**Historical Architectural Review Board  
COA Final Review Sheet**

**HDC-2022-00071; Amendment**  
**Address: 346 N. 8th Street**  
**District: Old Allentown Historic District**  
**Applicant: Andrew Ardizzoia, owner; Tom Weidner, contractor**  
**Proposal: Reconfigure and replace front steps; install railing**

**Revised proposal for front steps.  
(Applicant)**

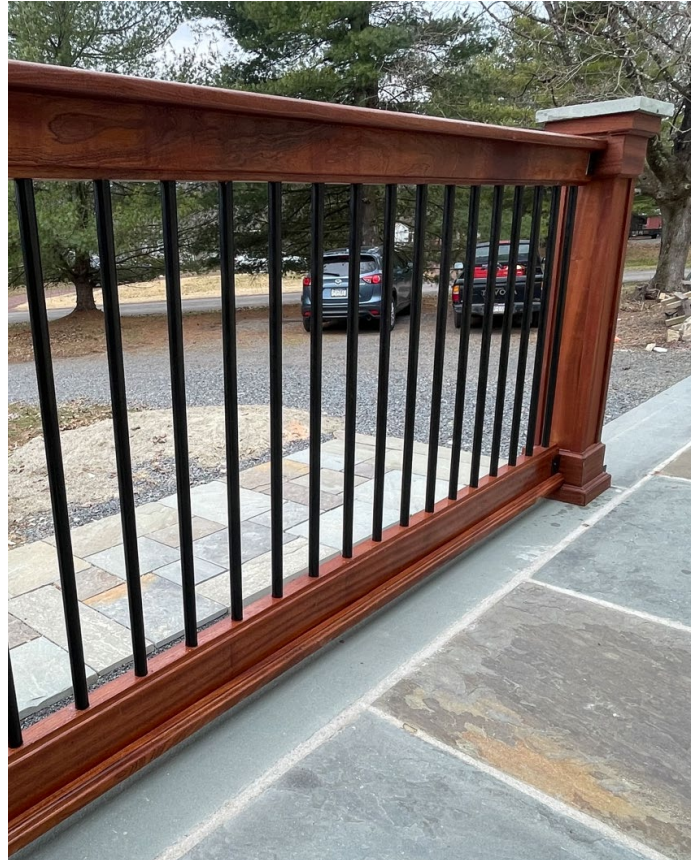
The application has been revised to comply with building code and avoid impeding in the right-of-way. According to the applicant, using standard stone slabs would require an additional step and would increase the projection into the right-of-way. The applicant further noted that custom stone slabs would be prohibitively expensive. The solution the applicant devised to meet building code is to include one course of bricks below each slab to raise the height of the step and eliminate the need for the additional step in the right-of-way. Staff finds the proposal acceptable since the steps are not intended to replicate an original condition. Steps at neighboring properties include a combination of slate treads and brick risers. Staff questions whether the combination of slate treads and brick risers would be more appropriate.

The proposed railings would consist of wood top and bottom rails with metal spindles and a wood newel post. Because the building is frame construction, staff finds the combination of wood and metal acceptable. Staff recommends anchoring the railing to the ground rather than the stone slab steps, since anchoring directly into the steps can accelerate deterioration.

Approval, with the staff to review details, pursuant to Chapter 3, Section 3.7 Porches & Steps. Staff notes that the property presents a unique circumstance because it has been moved, expanded, and its historic steps replaced in the past.

The contractor and owner are agreeable to following the building code and HARB recommendations. Building Standards and Safety recommends a riser height of 8 ¼ inches for the steps.

Mr. Huber moved to approve the application presented on 5/1/2023 for the reconfiguration and replacement of front steps and installation of railings at 346 N. 8<sup>th</sup> Street, with the staff to review details, pursuant to Chapter 3, Section 3.7 Porches & Steps, with the comment that the applicant may also consider a railing design consisting of all metal or all wood. Mr. Hart seconded the motion, which carried with unanimous support.

**Previous proposal approved by HARB.  
(Applicant)**

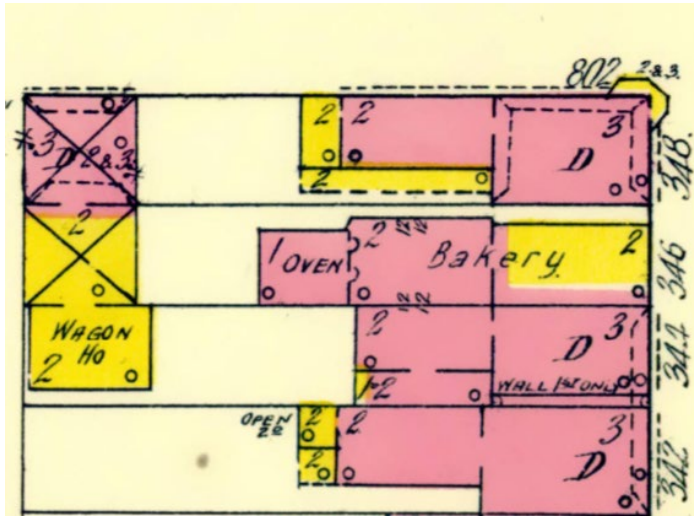
Since no documentation exists of the historic steps, staff supports the proposed configuration, which is typical of many historic rowhouses and most of the buildings on this block of 8<sup>th</sup> Street. The proposed configuration is consistent with Guideline 3.7.4 as a replacement that is historically appropriate in material and design in the absence of historic documentation. Staff suggests that a veneer on the cheek walls be avoided and recommends laying slab steps over curbing, such as in the image below. The steps should overhang the cheek walls by one or two inches. If the application is revised to include the suggested detailing, the application will comply with Guideline 3.7.4.
